LOCAL PLANNING PANEL – THE HILLS SHIRE COUNCIL

DETERMINATION OF THE LOCAL PLANNING PANEL ON 16 NOVEMBER 2022 – DETERMINATION MADE ELECTRONICALLY

ITEM 1: LOCAL PLANNING PANEL – PLANNING PROPOSAL – 21-23 VICTORIA AVENUE, CASTLE HILL (4/2021/)

ITEM-1 LOCAL PLANNING PANEL - PLANNING PROPOSAL – 21-23 VICTORIA AVENUE, CASTLE HILL (4/2021/PLP)**THEME:** Shaping Growth**MEETING DATE:** 16 November 2022

Figure 16
Floor Plans of Development Concept (Level 10 -12)

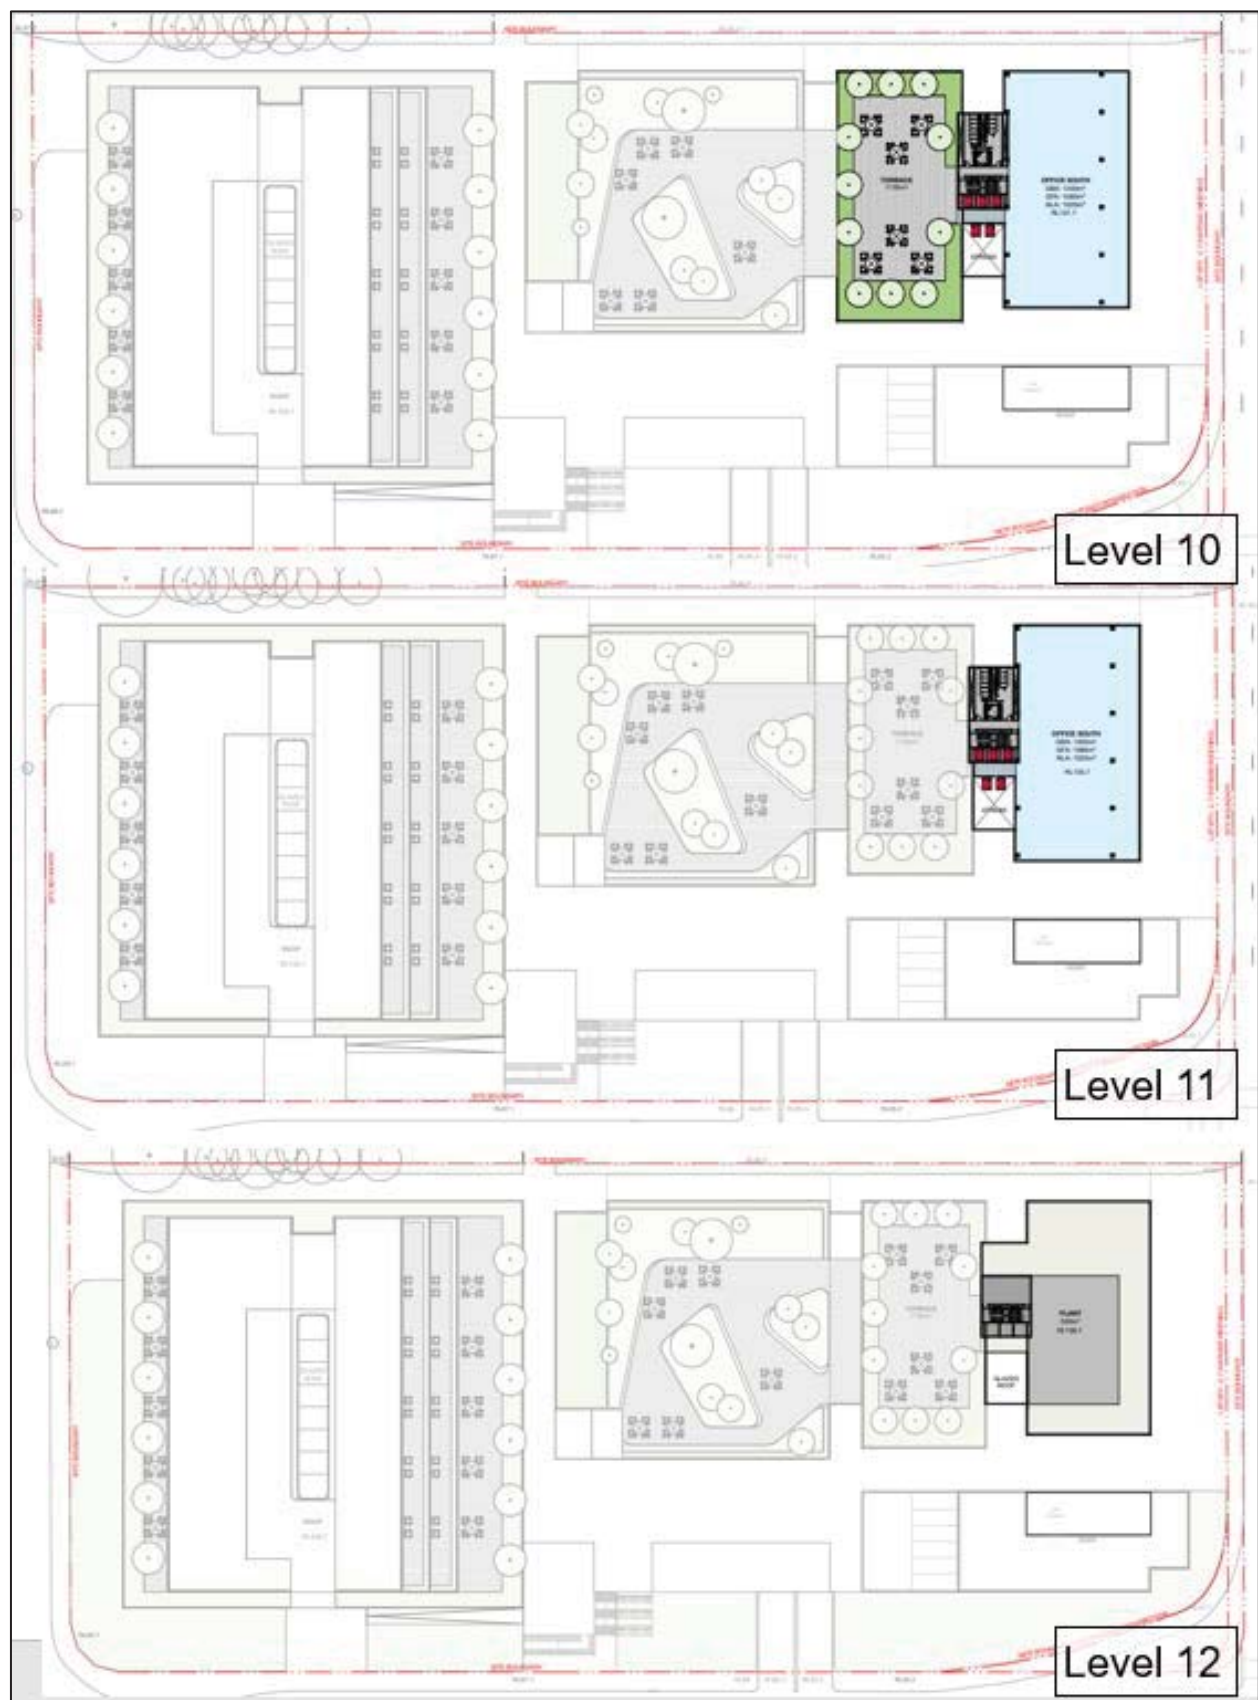
The following figures provide a level by level representation of the intended uses, which depicts the extent of building envelope that would need to be occupied by car parking if the proposed changes to the planning controls, as submitted by the Proponent, were to progress. As can be observed, this includes 4 storeys of large floorplates between the 3rd and 6th storey.

The floor plates associated with the proposed bulky goods retail uses (lower ground and upper ground) are very large, in the order of up to 5,000m², which is typical for bulky goods retail. The provision of these floor plate sizes to accommodate the continuation of retail outcomes on the site is supported. However, the extrusion of these floor plates for an additional 4-5 storeys, to accommodate car parking within the building envelope is problematic from a bulk and scale perspective.

Figure 19
Section of development concept with potentially appropriate building forms outlined in blue

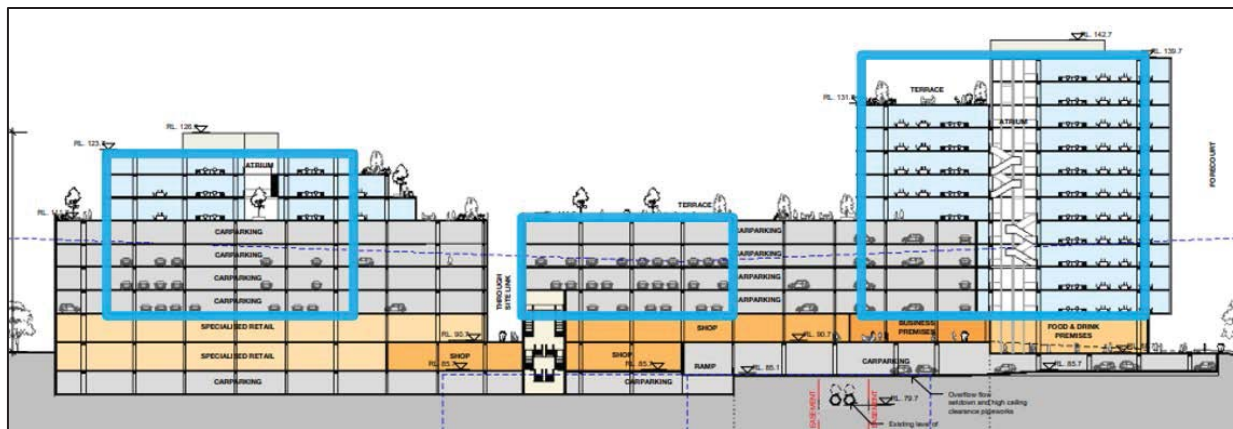
parking and proposed floor plates detailed above. The east elevation at the ground plane demonstrates a total building length of approximately 190 metres, with only 6 metres of separation between the two buildings at the location of the through site link.

Council officers have marked up a diagram below to indicate potentially appropriate tower building envelopes that could result in a more acceptable built form outcome in this context of this site and the current and future character of the locality. It is noted however that this outcome would accommodate substantially less gross floor area (and associated parking areas) within the building envelopes in comparison to that being sought by the Proponent. The Proponent has previously been advised that consideration should be given to reducing the extent of FSR sought in order to relieve these built form issues.

Figure 21
Proposed setback controls within Proponent's draft site specific DCP

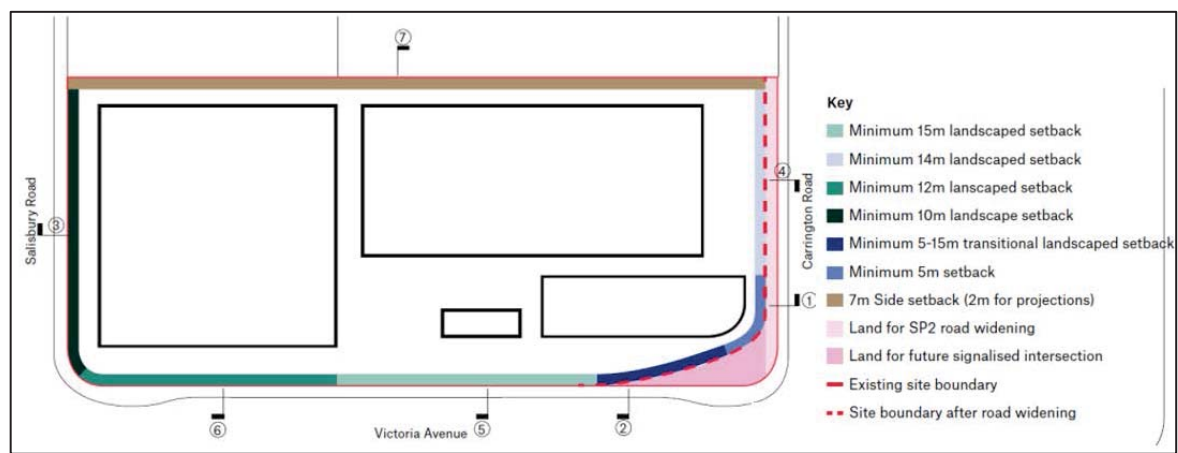
The development concept indicates setbacks of 10m-15m to the street, as shown below. Consistent setbacks have been applied throughout the locality to deliver a consistent streetscape with substantial landscaping and an attractive public domain. The proposed DCP controls would result in a development that is inconsistent with the controls that neighbouring development would be required to comply with. However, as the planning proposal will result in change of character across the site from industrial/specialised retail premises to high density commercial, it is considered potentially appropriate that the front and side setback outcomes are reduced marginally, because of the role they play transitioning uses along Victoria Road.

The proposal also seeks to provide a 7m setback to the rear boundary with 2m for projections (when the Industrial DCP would require 5 metres). The rear setback is considered to be sufficient for creating building separation to the neighbouring development at the lower levels, however when considering the rear interface in its entirety, it is overcome by the impacts of excessive height, length and building bulk, as detailed previously in the report.

The planning proposal would be improved by DCP controls requiring greater building separation, more detailed articulation zones, visual analysis to illustrate perceived bulk from

Figure 24

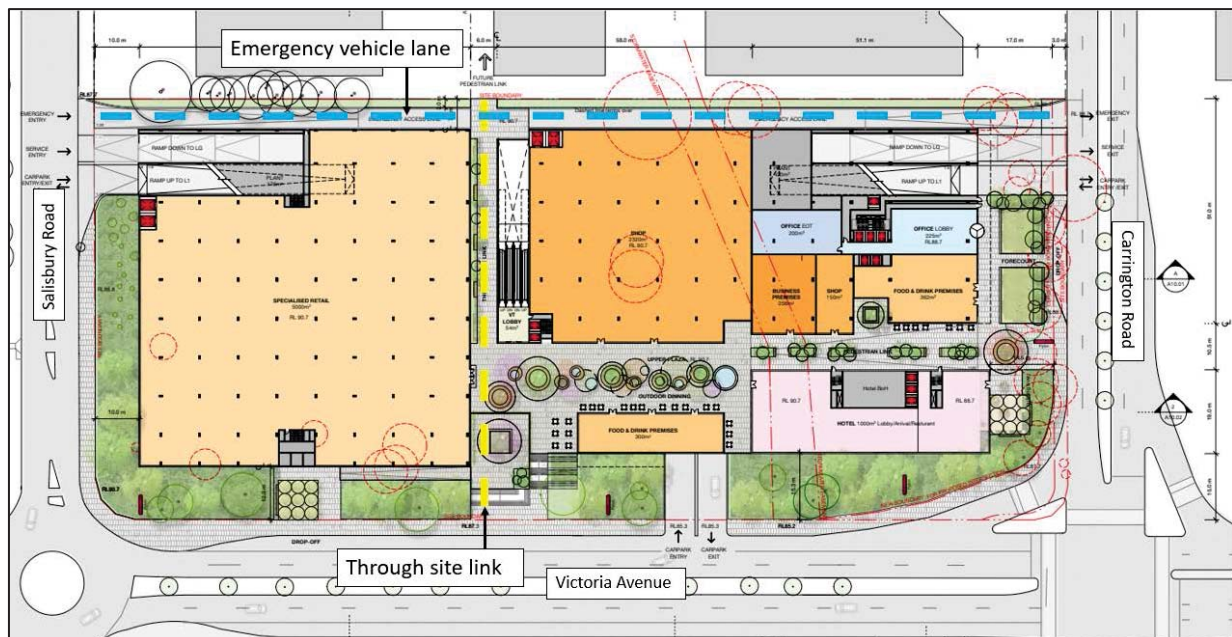
- The proposed through site link is inconsistent with the design criteria in the Showground Station Precinct DCP controls, including being clearly identifiable as a publicly accessible pedestrian link, encouraging pedestrians to move along the link and not linger; ensuring adequate passive surveillance is provided, having adequate lighting to improve safety and appropriate building setbacks.
- The through site link is intersected by a service/emergency access road along the rear boundary of the site, which will inhibit pedestrian movements and potentially be dangerous as pedestrians will interact with delivery, service or emergency vehicles.

Any revised proposal should provide a through site link that demonstrates consistency with the Showground DCP, is at grade, does not intersect with a service road, be accessible for people with a disability or in wheelchairs and be easily identifiable, welcoming and encourage pedestrian use. Further consideration and prioritisation of the through site link in the design of the development is needed to positively contribute to the pedestrian infrastructure and permeability. The management of the service land and its relationship with the through site link could potentially be addressed through measures such as timed service vehicle access or boom gates, however this would be a last resort to rectifying the site planning issues identified within this report as part of the planning proposal application. Furthermore, the viability of this type of arrangement would likely depend on the final make-up of uses within a future Development Application.
